**TOWN OF NEWBURGH
PLANNING BOARD
TECHNICAL REVIEW COMMENTS**

PROJECT NAME: GARDNER RIDGE
PROJECT NO.: 2-29
PROJECT LOCATION: GARDNERTOWN ROAD NEAR GIDNEY AVENUE
SECTION 75, BLOCK 1, LOT 4.12
REVIEW DATE: 10 JUNE 2022
MEETING DATE: 16 JUNE 2022
PROJECT REPRESENTATIVE: THOMAS B. OLLEY, P.E., P.L.L.C.

The following items are in response to comments in the Creighton Manning letter dated October 18, 2021. The items are numbered according to their review comments.

The following items are in response to comments contained in the MHE Engineering, D.P.C. letter dated October 21, 2021. The items are numbered according to their review comments.

GRADING PLAN
GARDNER RIDGE
GARDNERTOWN ROAD
TOWN OF NEWBURGH, ORANGE COUNTY, NY

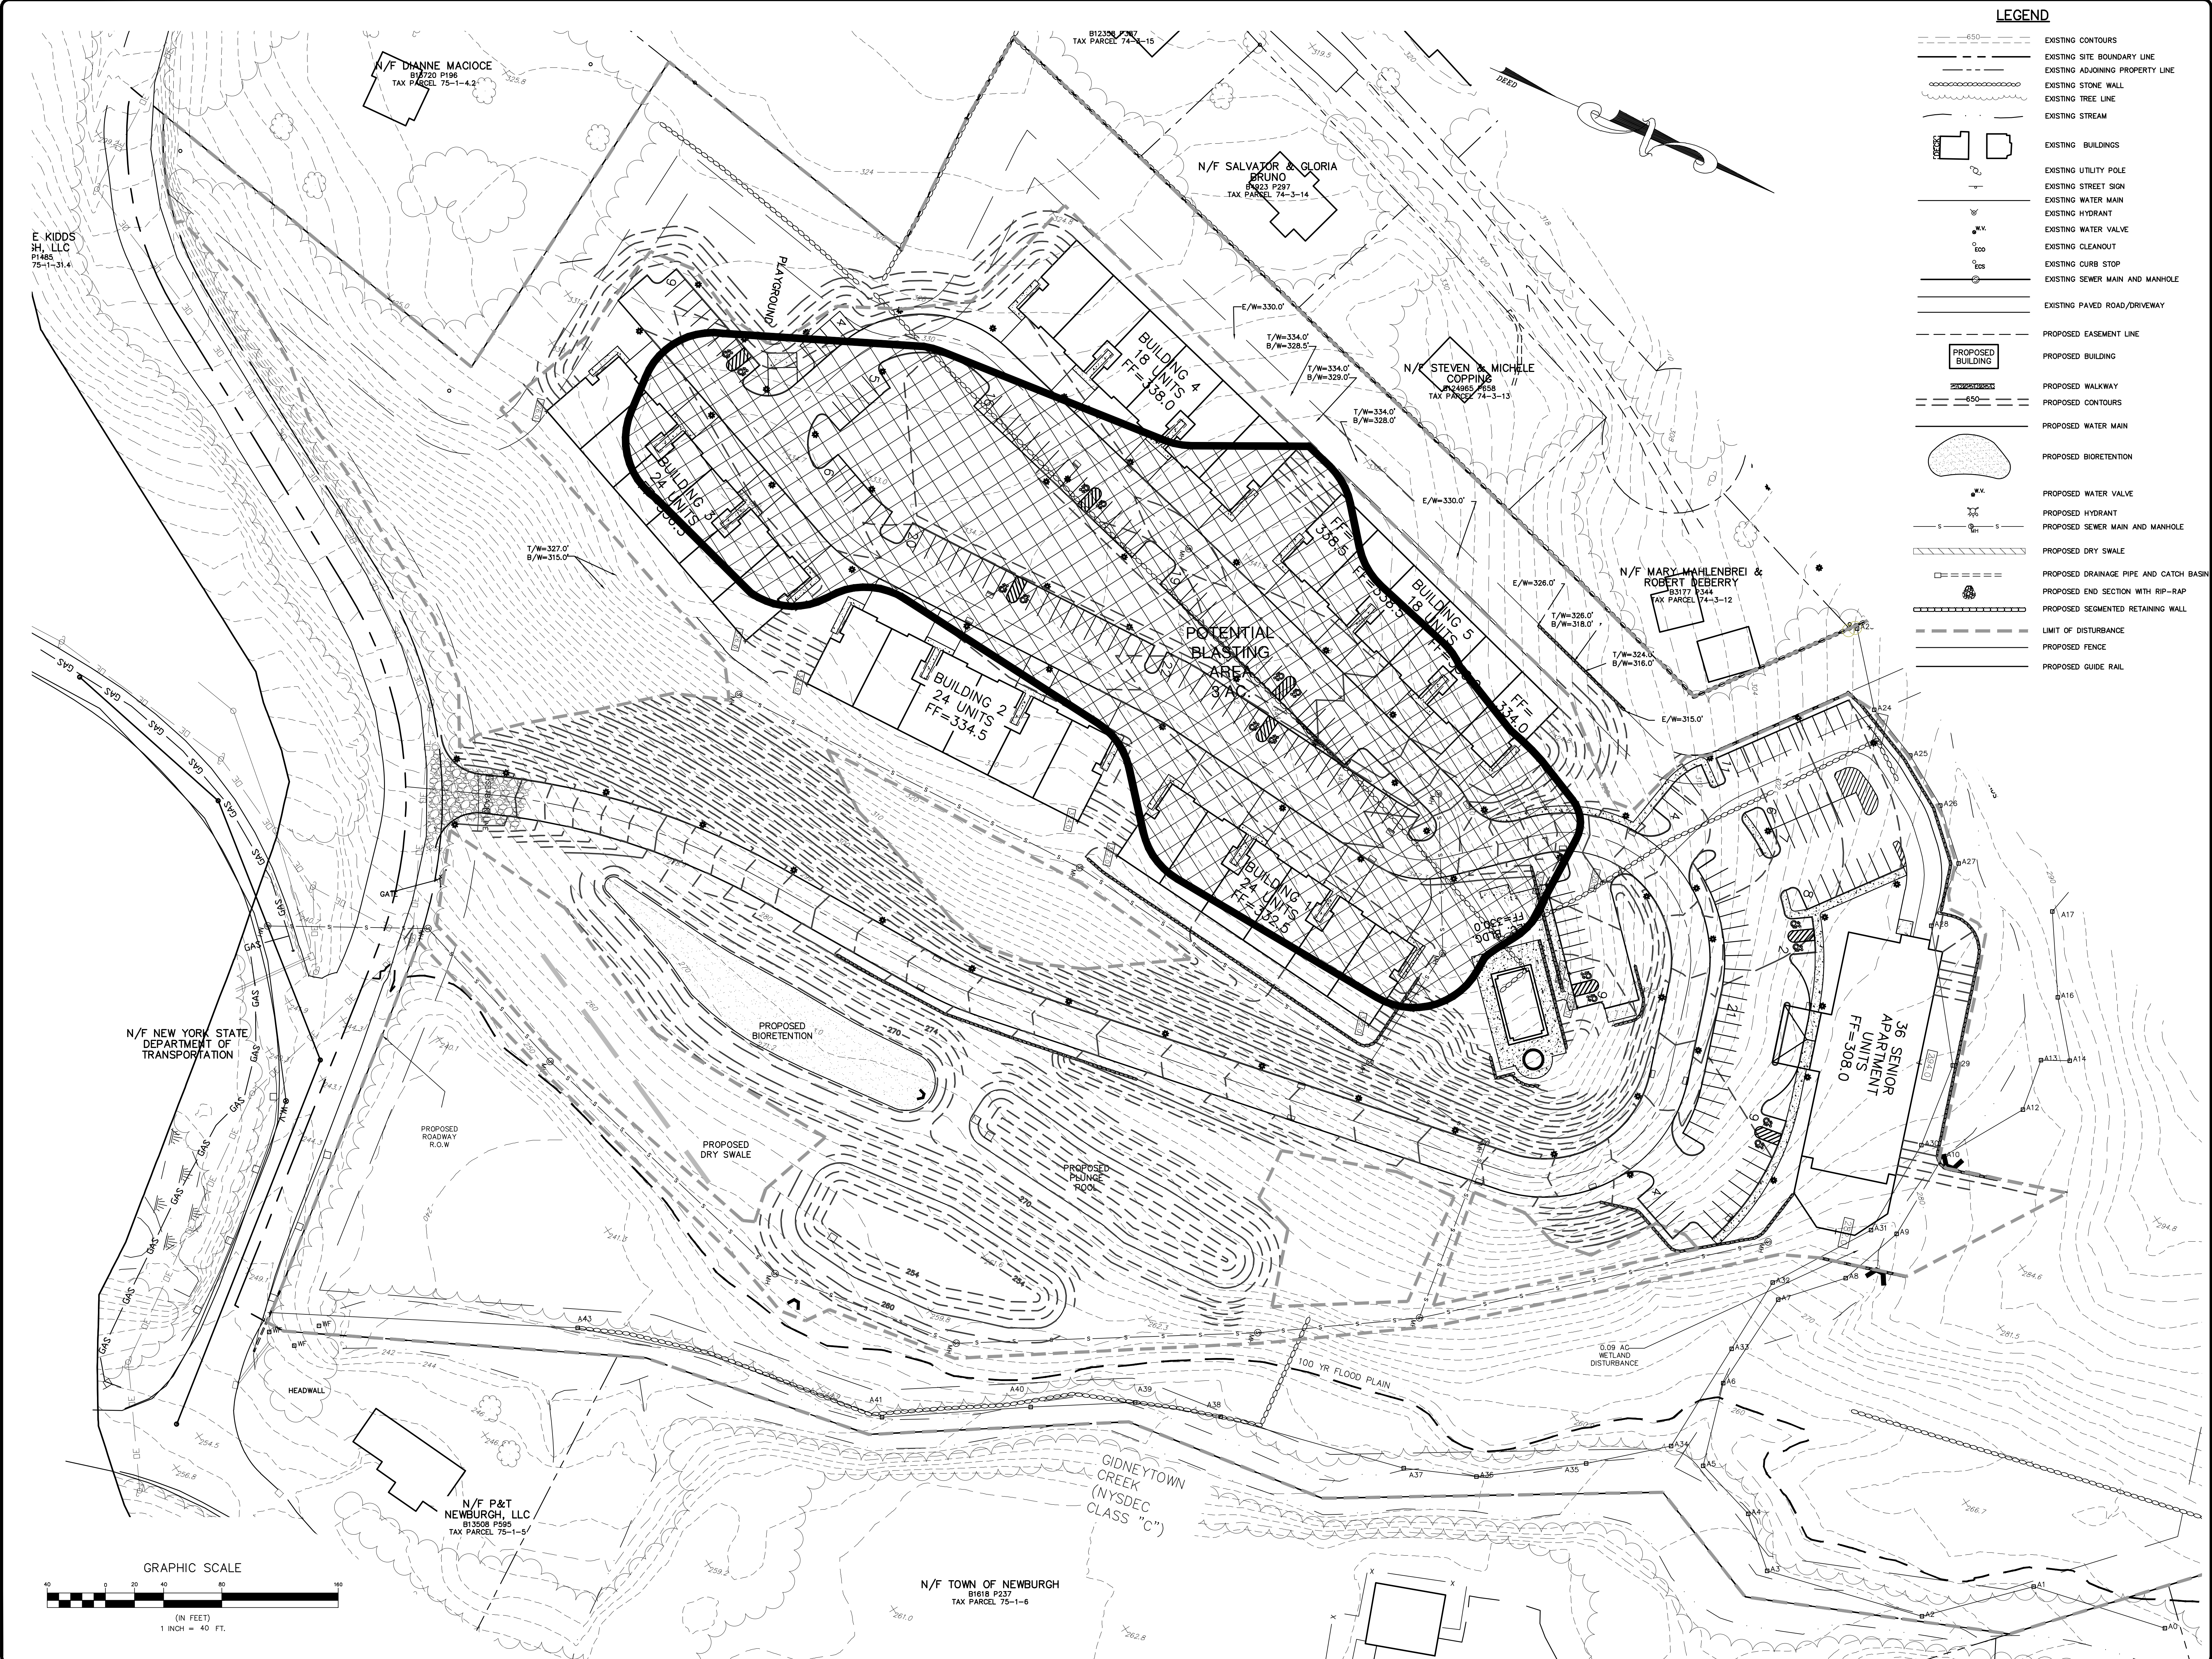
6. Additional labeling of the grading plan is required to accurately review the plan. The depicted as potential blasting area of 3 acres should be removed from the majority of the plans as the crosshatching obscures the underline information. Grading plan should identify top and bottom of all retaining walls proposed.

TYPICAL ROAD CROSS SECTION
NOT TO SCALE

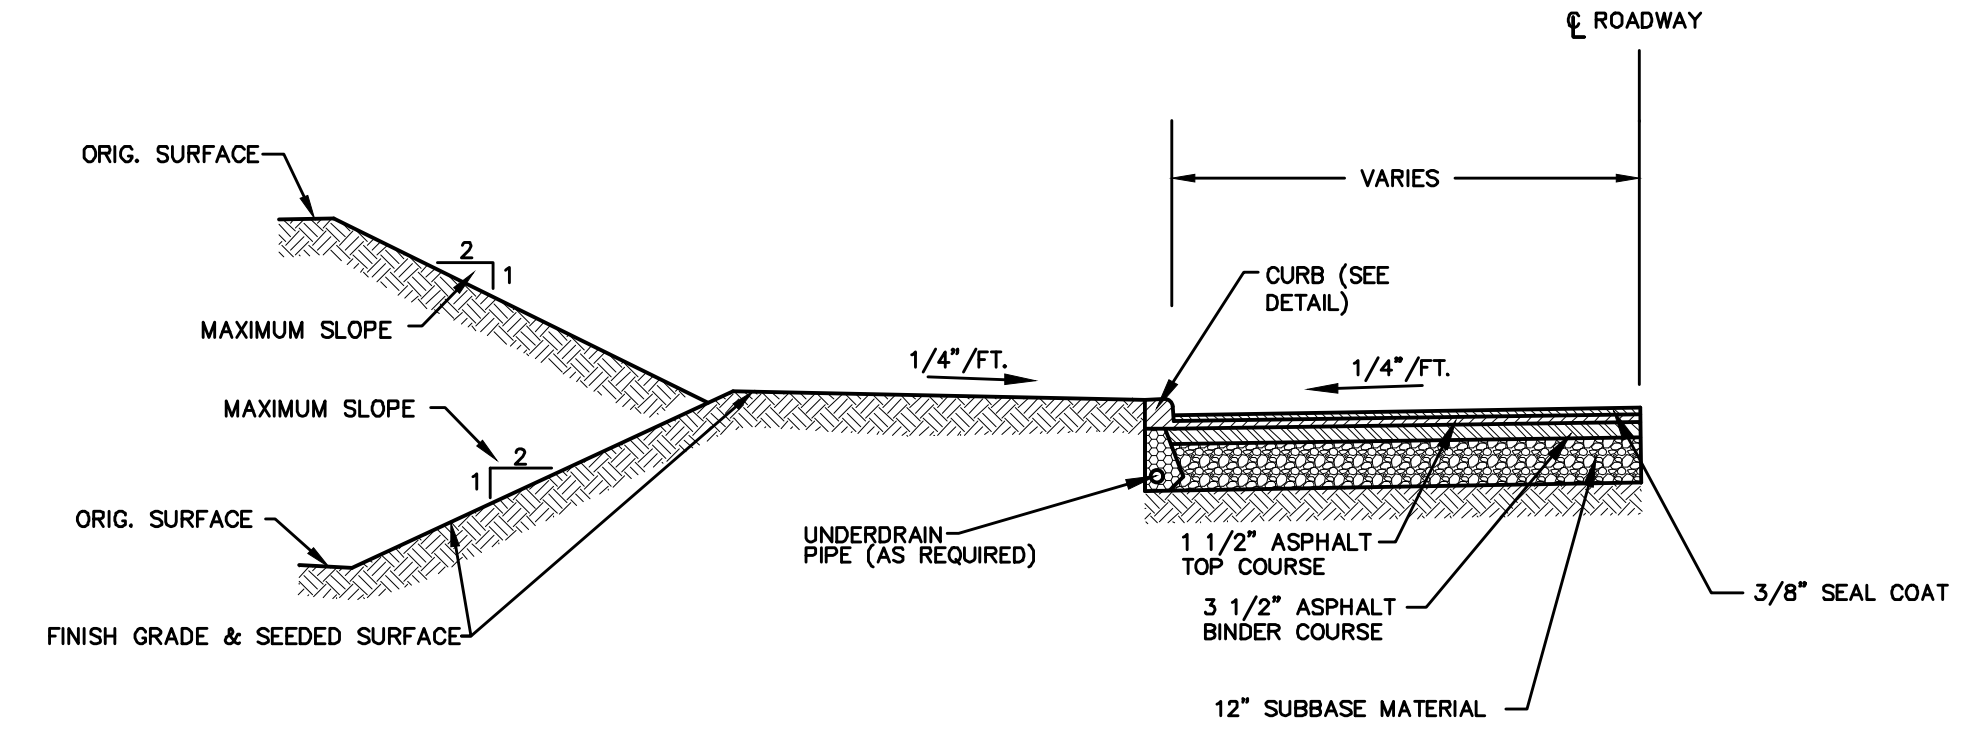
9. City of Newburgh Flow Acceptance Letter should be addressed.
10. Typical road cross section details should identify the width of all roadways. Width of the road is identified as varies.

EMERGENCY ACCESS GATE
NOT TO SCALE

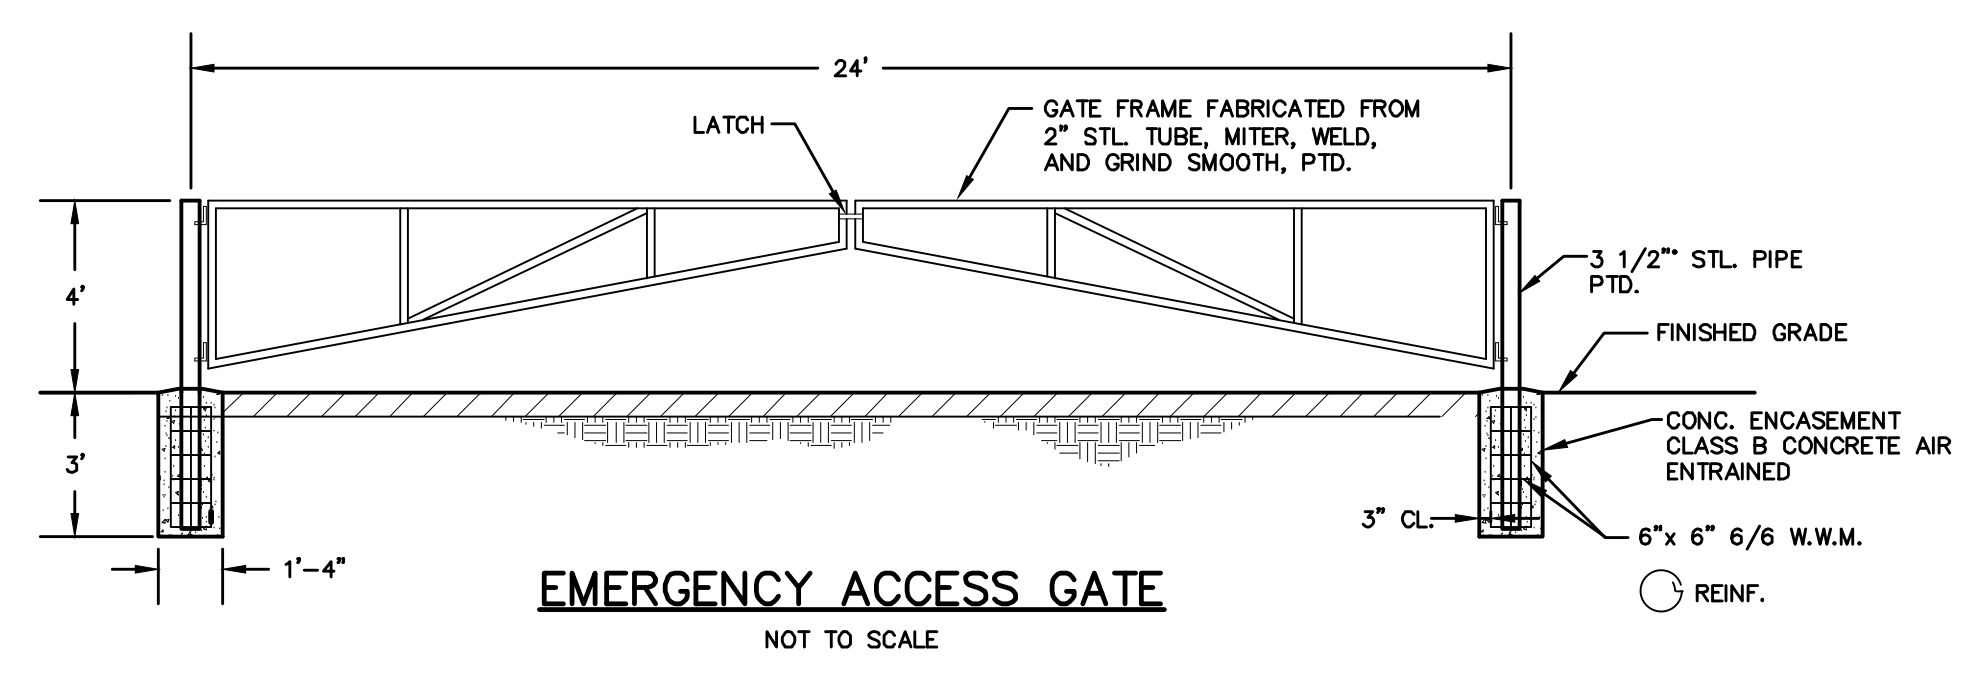
11. Emergency access gate is identified on the plans. Location of this emergency access gate should be identified.
12. The project site has a single point of access currently proposed.
